37/03-06YY 7101 CEDAR AVE

Takoma Park Historic District

SUBJECT: Historic Area Work Permit #4324543, rear addition and gazebo construction

HISTORIC PRESERVATION COMMISSION STAFF REPORT

1 Gazebo Rear Elevation
1/2" = 1'-0"

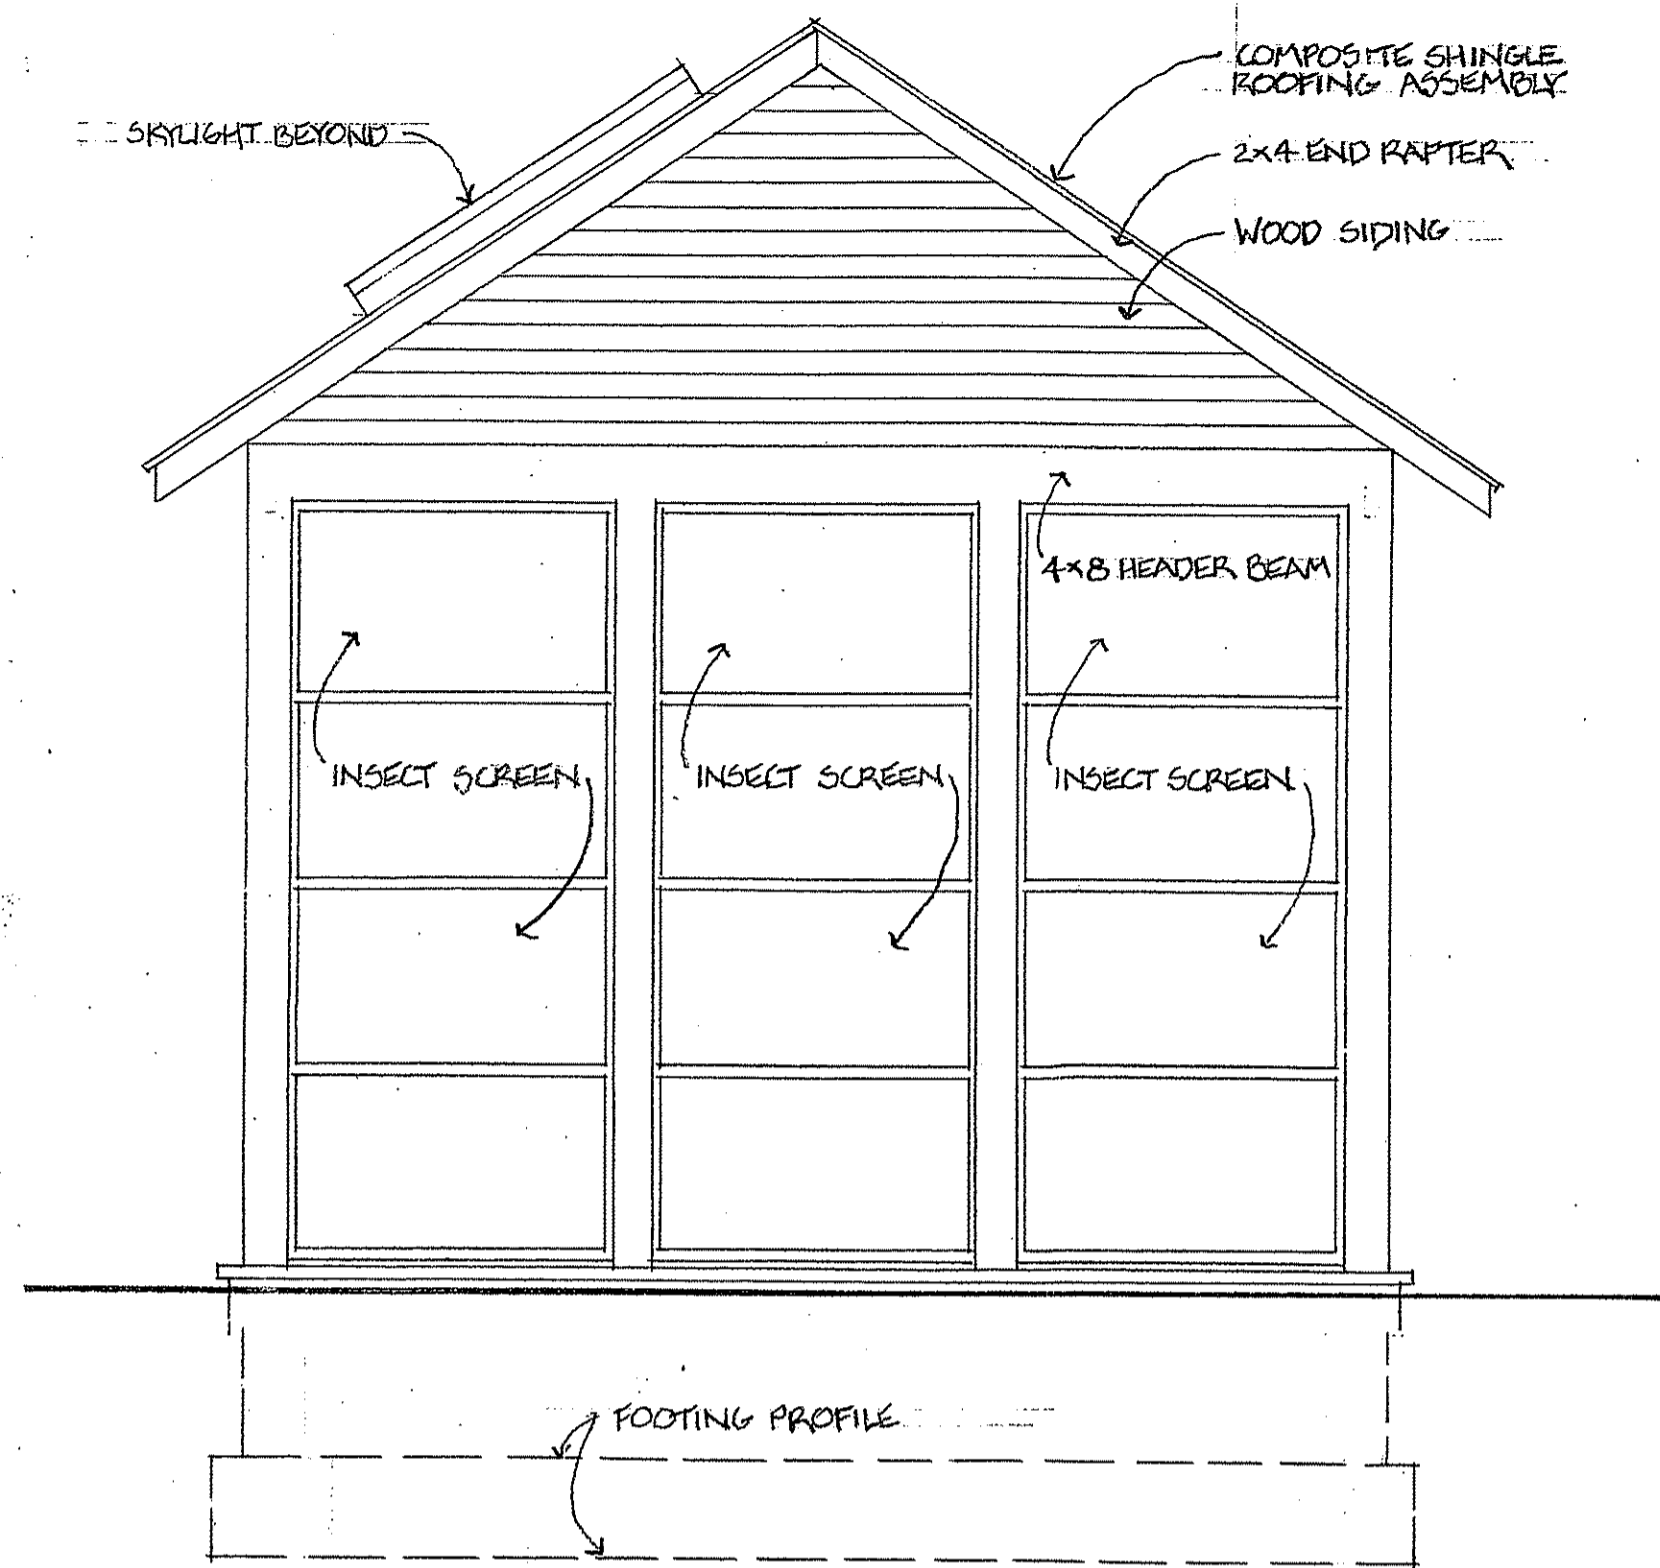
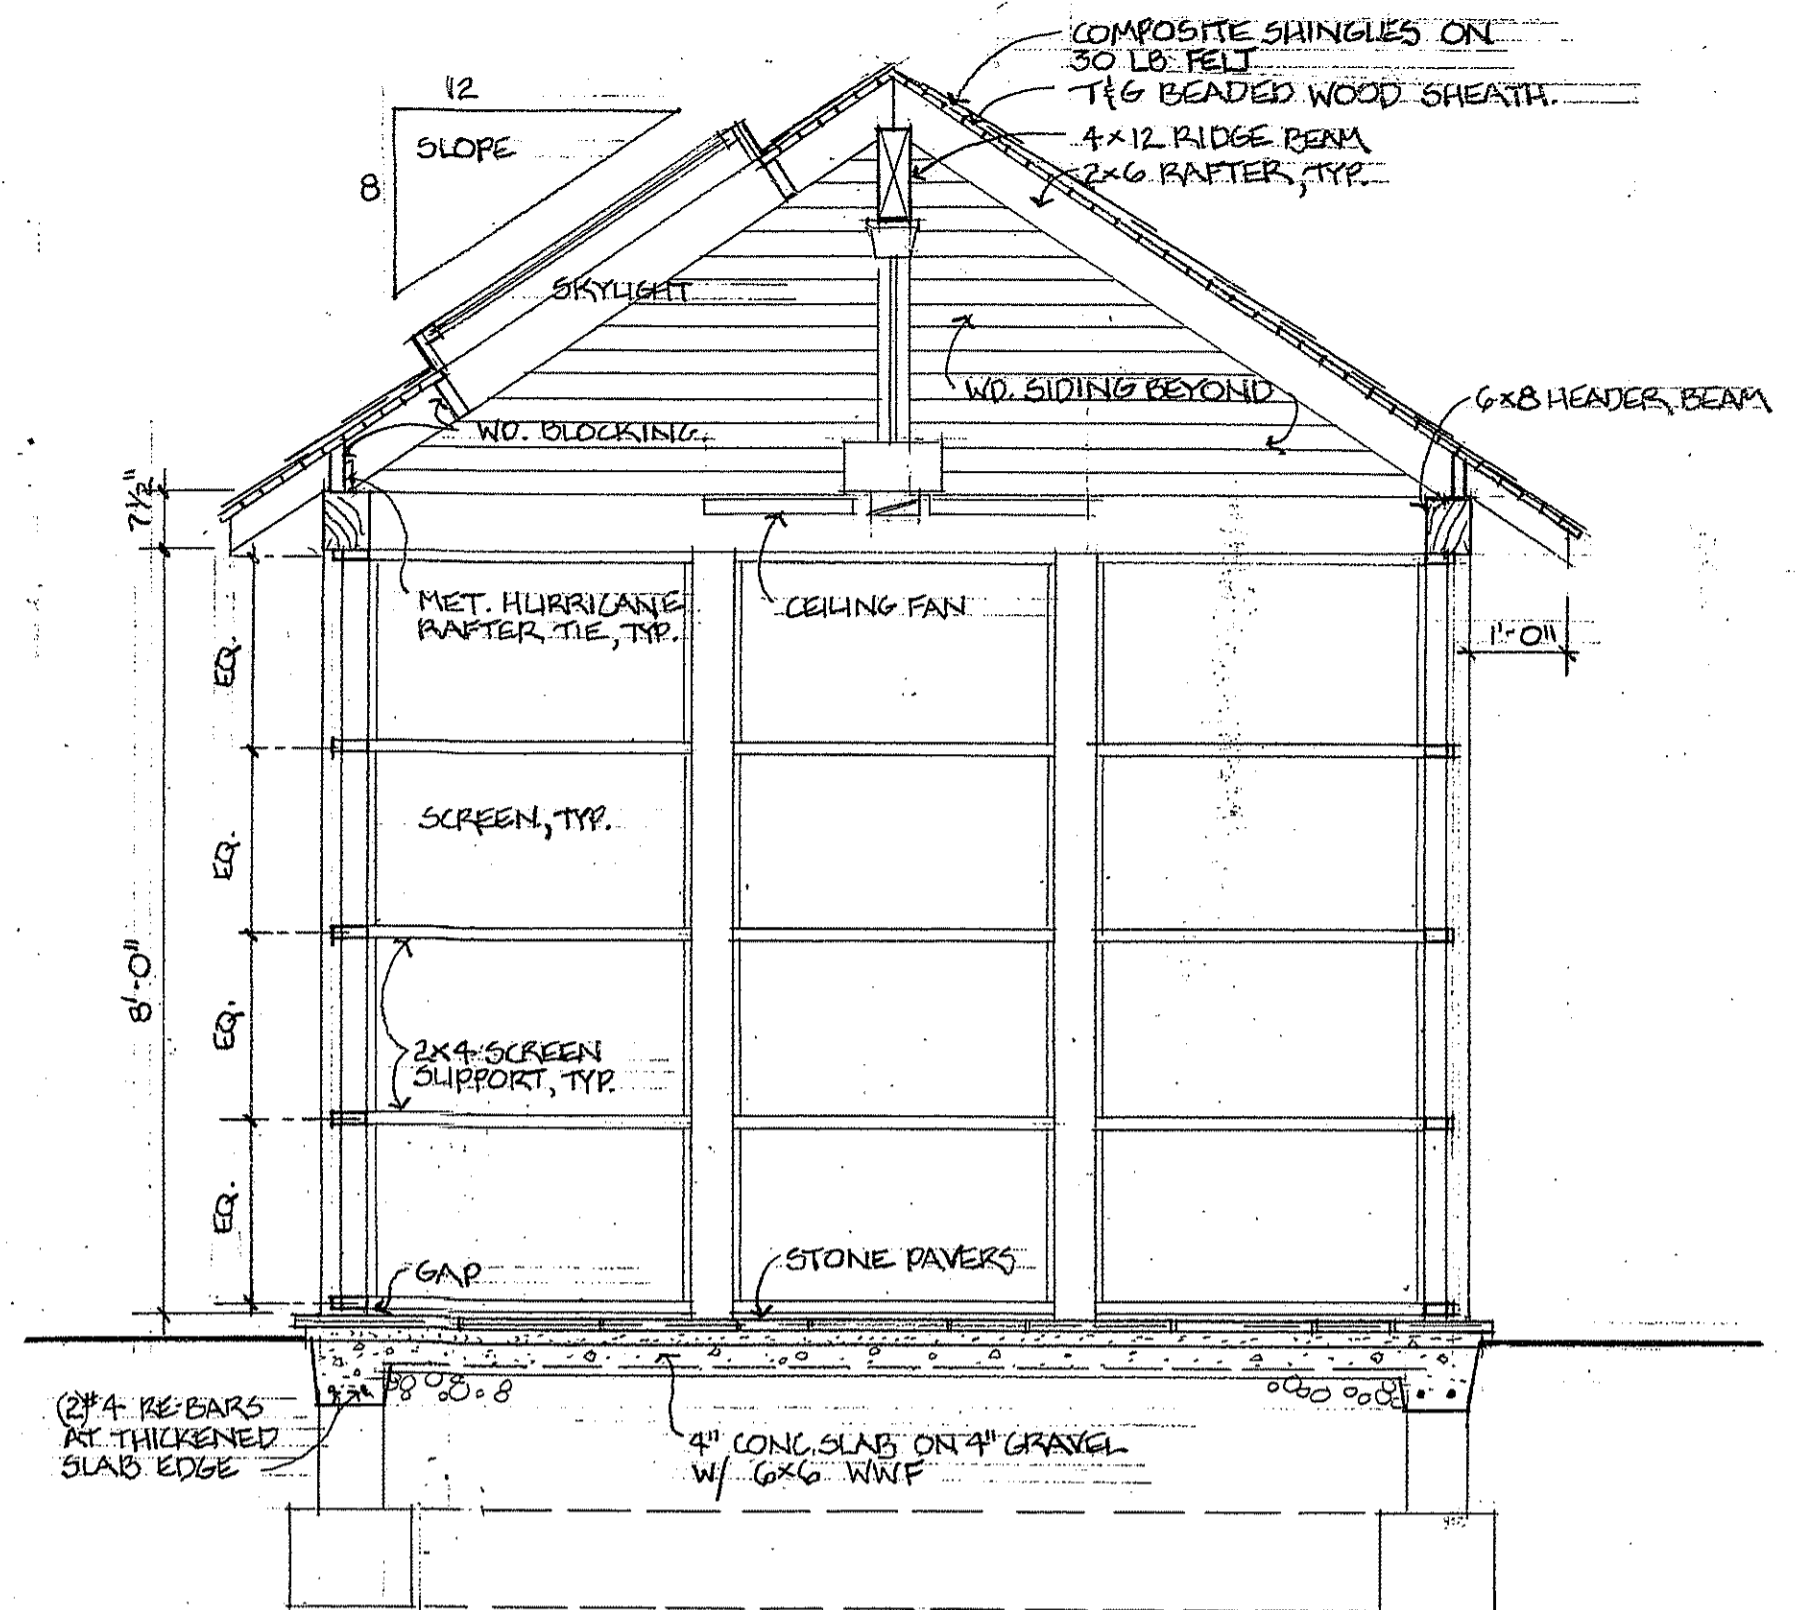
DPS said no to gazebo →
needs to be rebuilt
the way. They won't
build it for now.
Will send patio plan
for stamping.

7101 Cedar new gazebo approved
they want to install a skylight

approved by MPC
10-25-06

Site Plan
3/32" = 1' - 0"

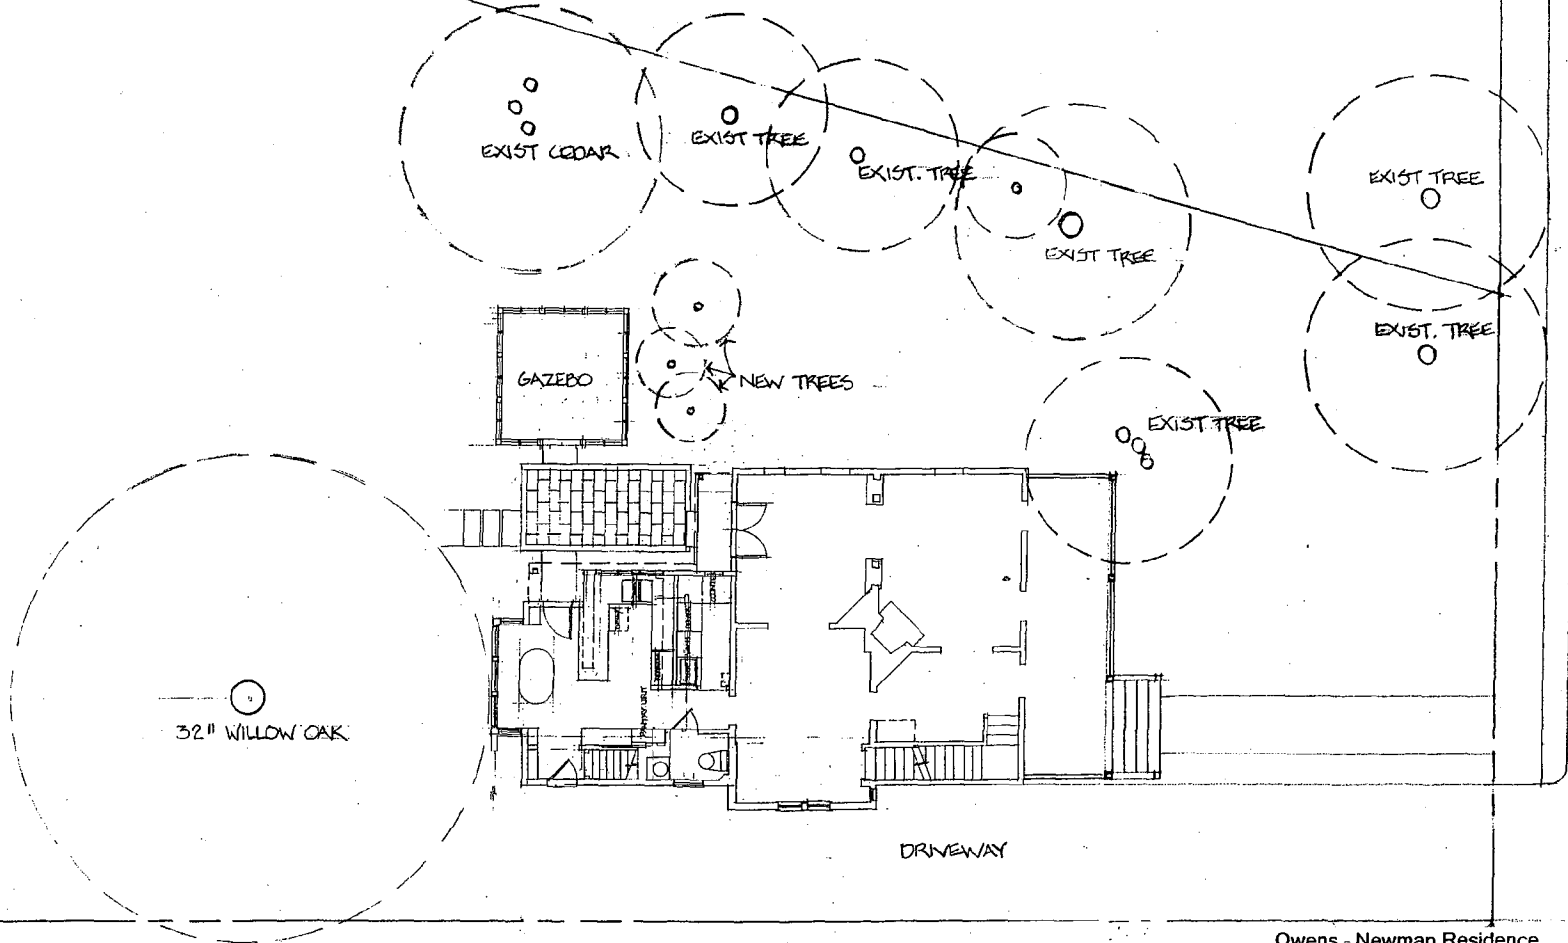
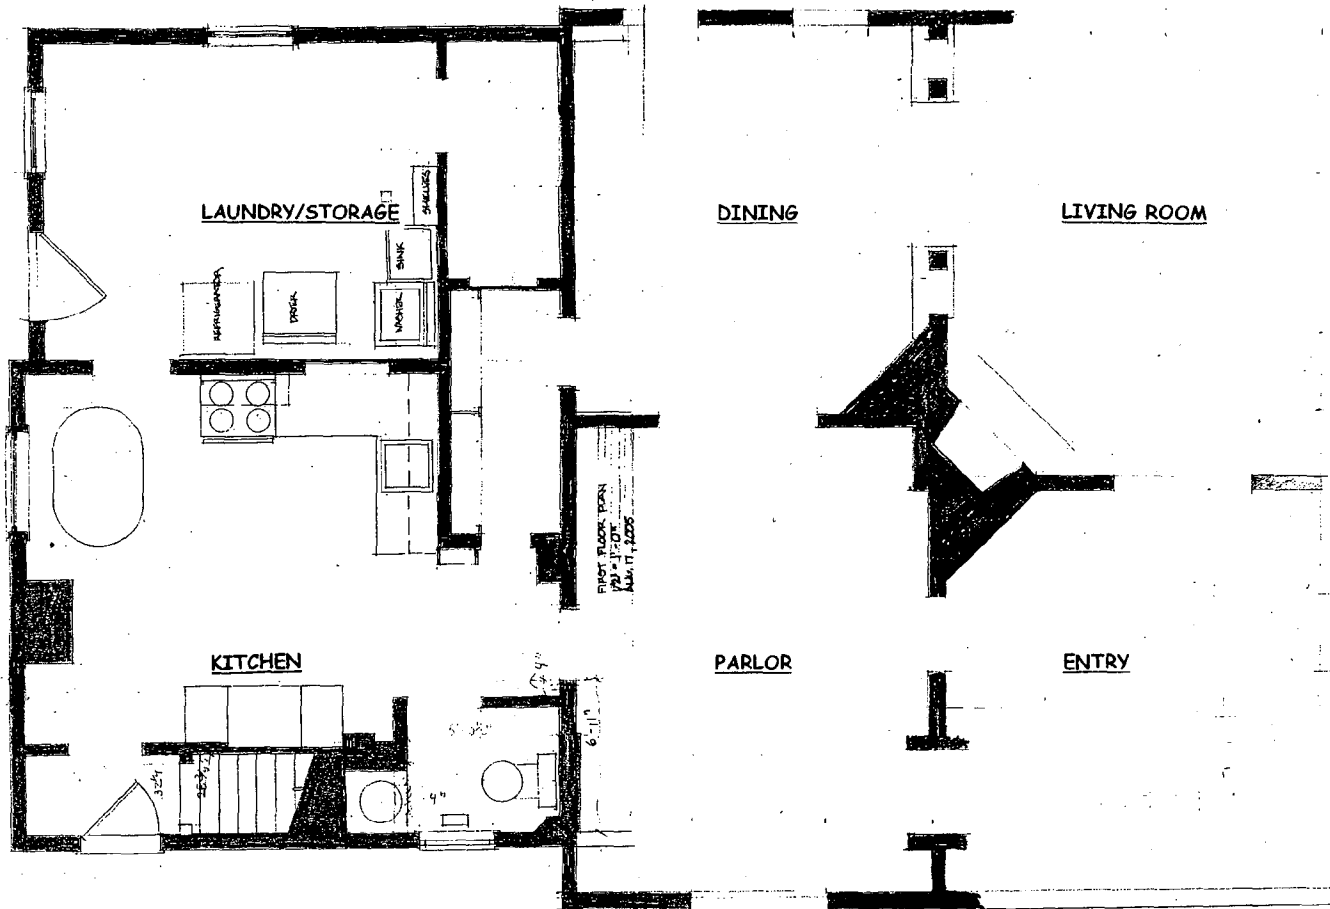
Covered walkway: Some HPC members questioned the plan for a connecting covered walkway linking the house to a freestanding screened-in gazebo.

As you will note from the revised drawings and photographs, the area where we propose to place the gazebo is already partially screened by two large trees (a hemlock and a maple) on the street side of the gazebo, and other large trees in the front yard. To lessen the visual impact of the gazebo from the street even more, we propose to add new screening trees and shrubs at the street side of the gazebo. In recognition of this structure as now completely separate from the original house and, what could be interpreted as the 'temporary' nature of the structure, we ask for the HPC's forbearance on this issue.

Response: The roof connecting the structures has been removed.
